Grandstream Networks, Inc.

Request for Class II Permissive Change

FCC ID: **YZZGXV3610-FHD**

Date: March 26th, 2014

New mainboard bottom view

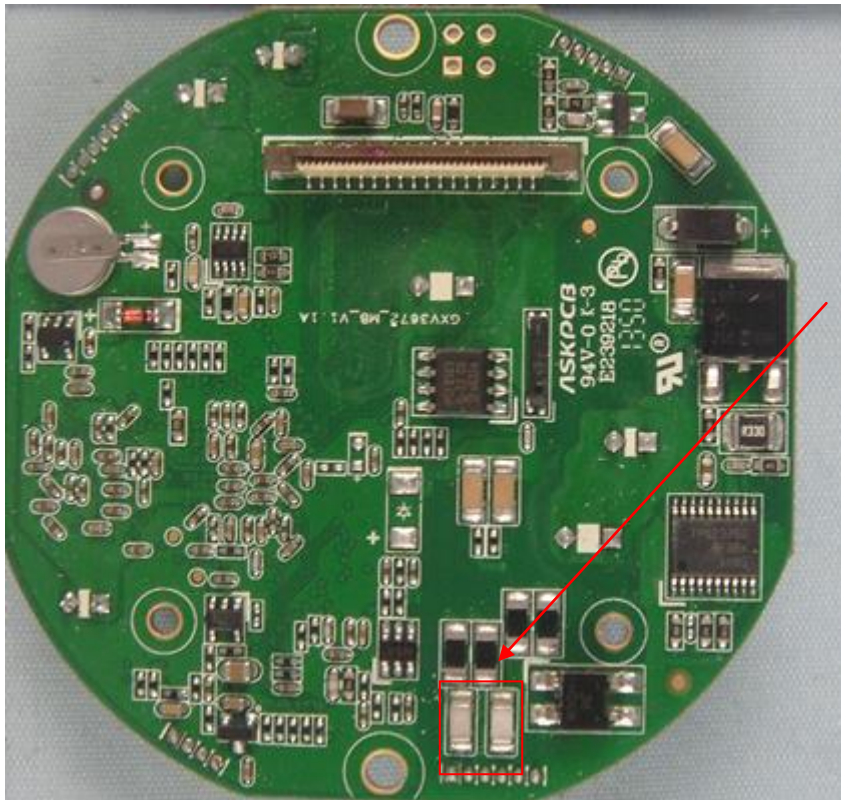
1. Added two GDT (gas-discharge tube) to protect products

New IR LED board view

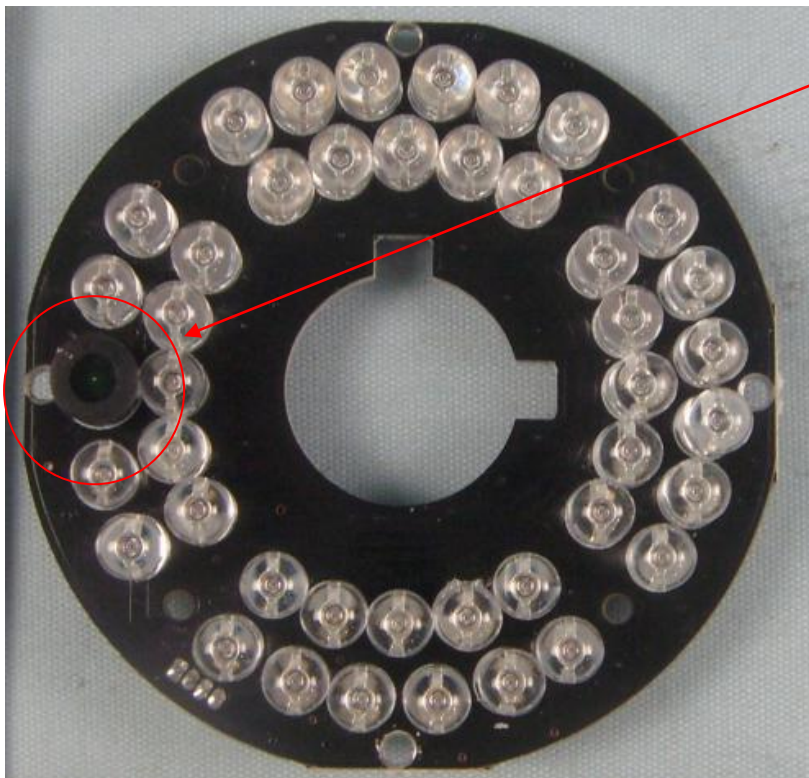
2. Changed the CDS to the light sensor on IR LED board

New IR LED Borad view

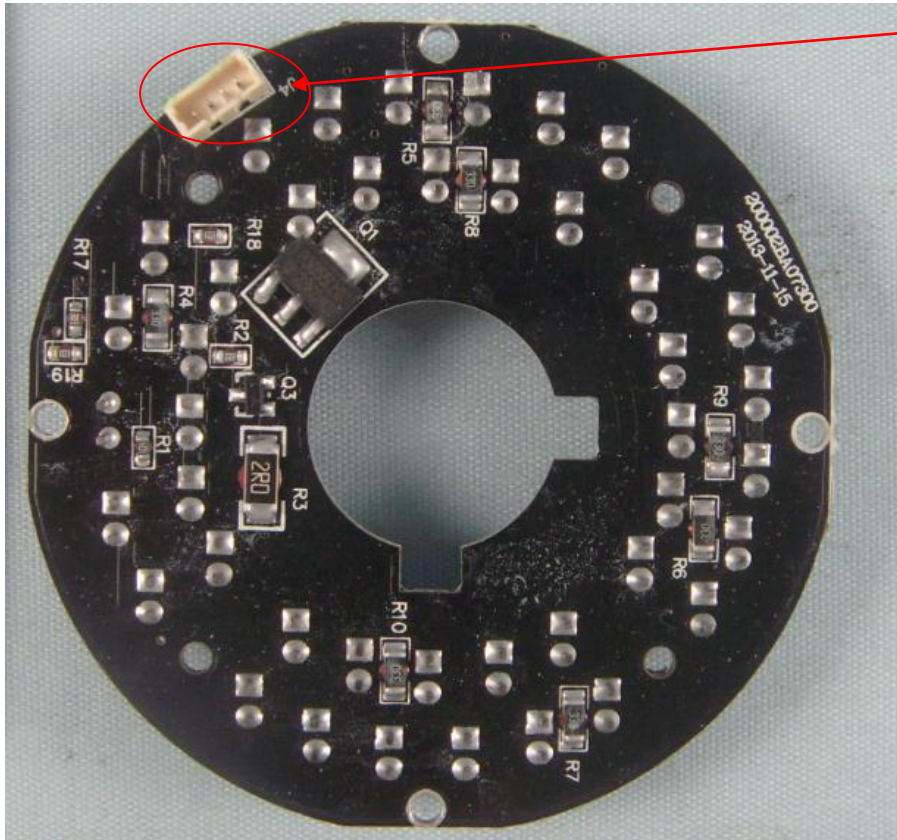
3. Changed the connector to 4 pins on IR LED board

Top view for original main board:

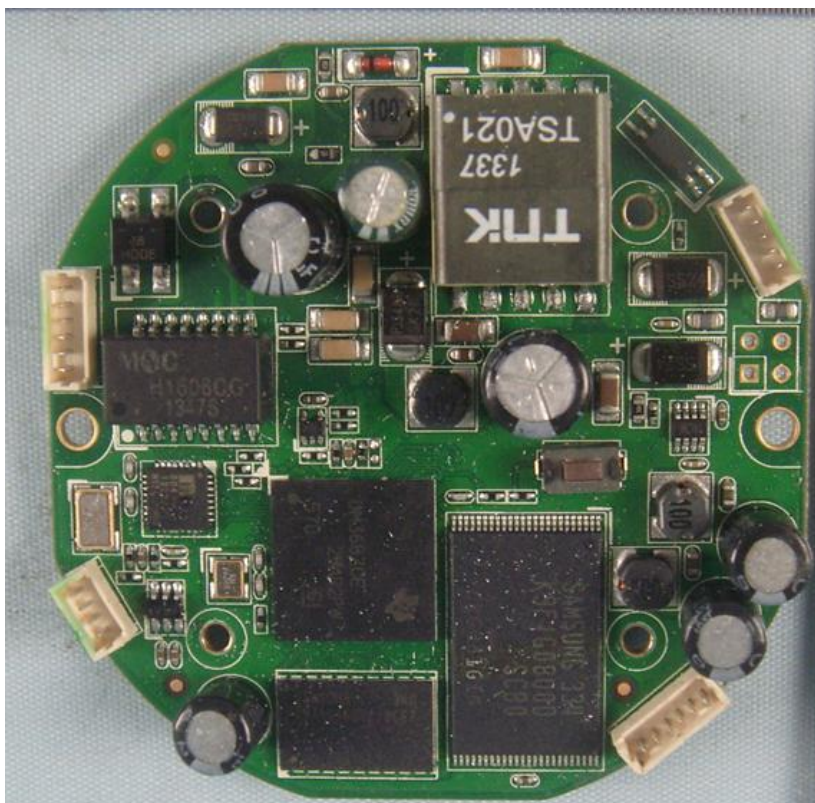
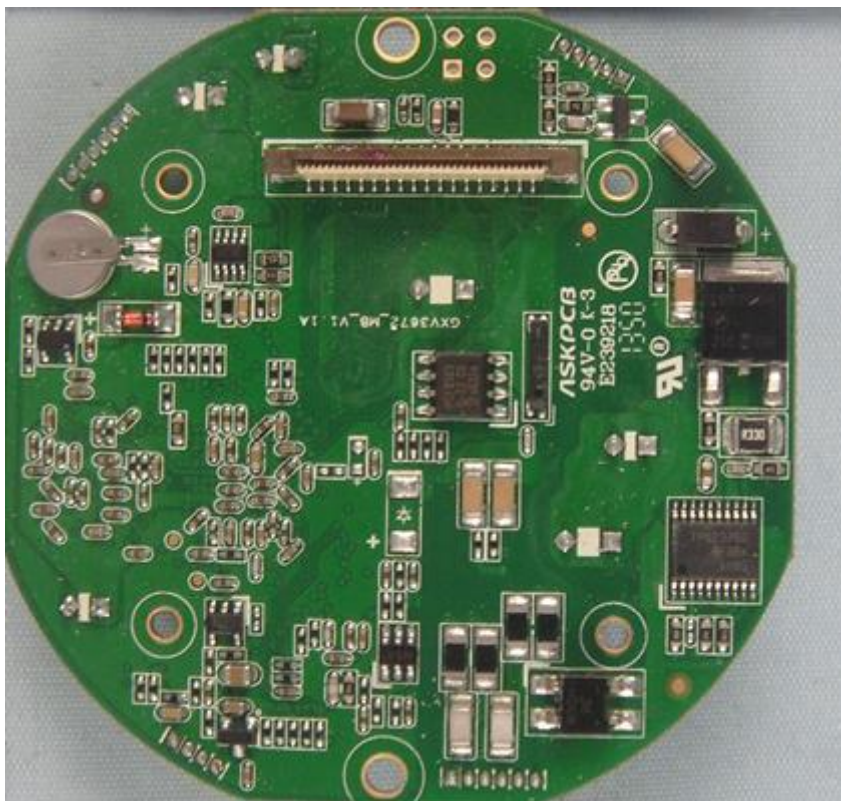
- 4. Changed the shape of main board from quadrate board to circular board.
- 5. Changed PCB Layout.

Bottom view for original main board

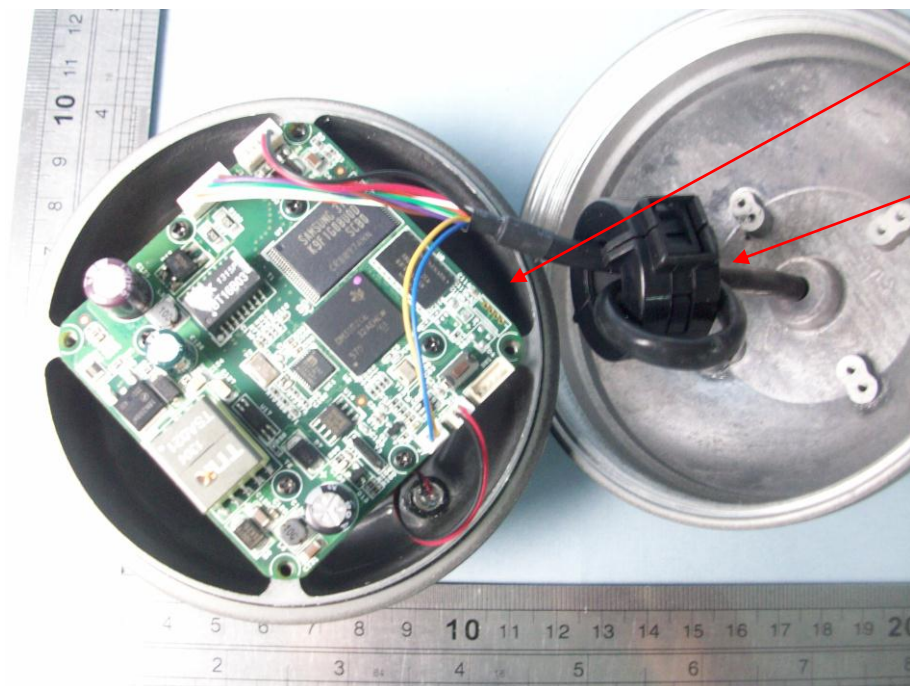
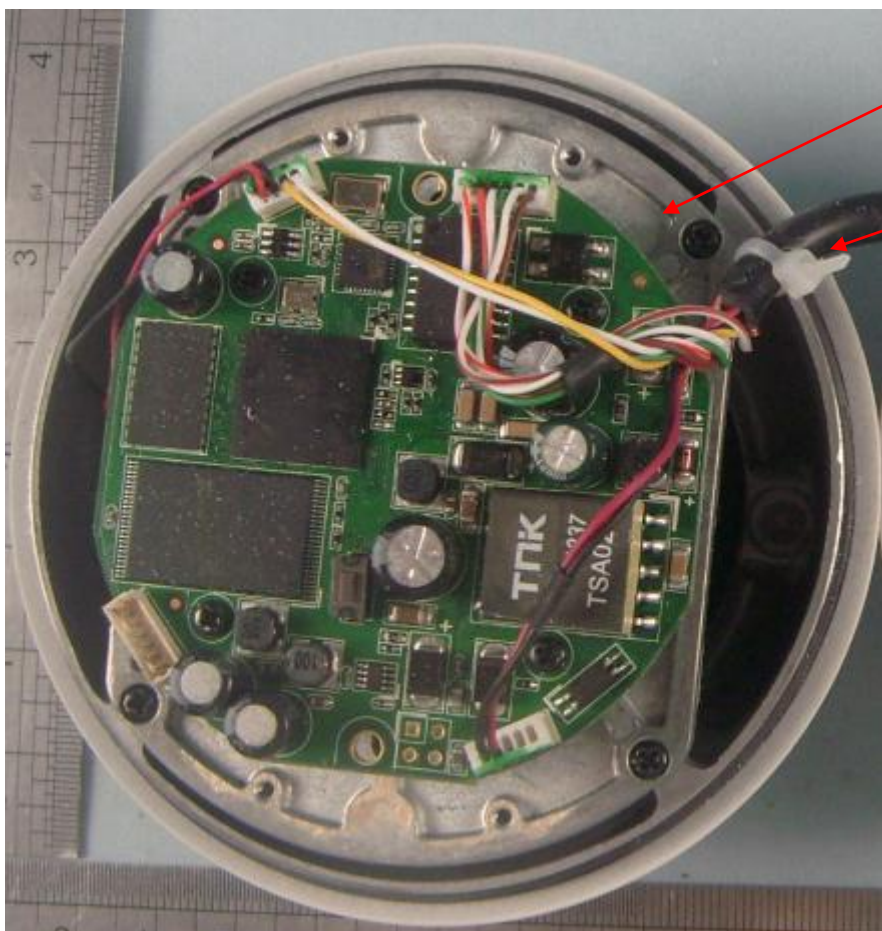
- 6. Original product has not metallic board.
- 7. Original product has a ferrite core.

- 8. New product has a metallic board.
- 9. New product has not a ferrite core.
